**86100C-04**

# S E R V I C E N O T E

## 86100C Infiniium DCA-J Wide Bandwidth Oscilloscope

**Add Diode Limiter to DCA trigger port to prevent A14 Counter Assembly electrical overstress damage.**

Figure 1, A14 Counter board Mounted on the A13 Acquisition Assembly

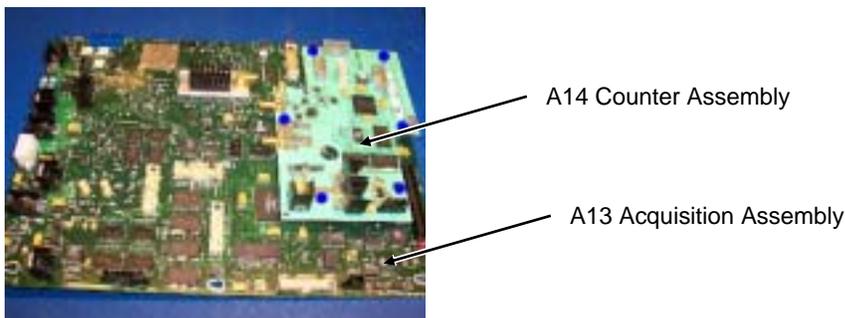
1. Once the A13 Acquisition Assembly and the A14 Counter Assembly are removed from the DCA chassis, position them as shown in the figures below. Remove the existing cable W31, part number 86100-20053, from the A14J2 INPUT and discard.

Figure 2, Cables W32 and W31 (circled)

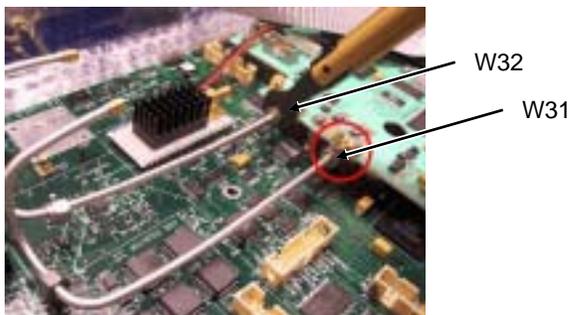
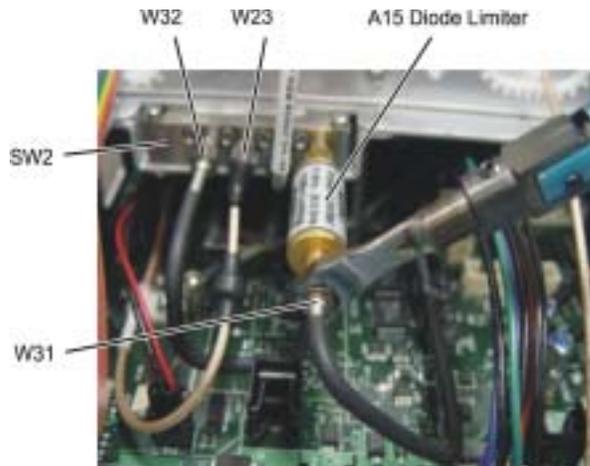
2. Connect the new W31, part number 86100-20082, to A14J2 INPUT. The W32 cable remains connected to the A14J3 OUTPUT.
3. Install the A13 Acquisition Assembly and the A14 Counter Assembly into the DCA chassis.
4. Connect cable W32 (from A14J3) to SW2P1 as shown in Figure 3 below. Torque the 5/16" connector to 8 in-lbs.
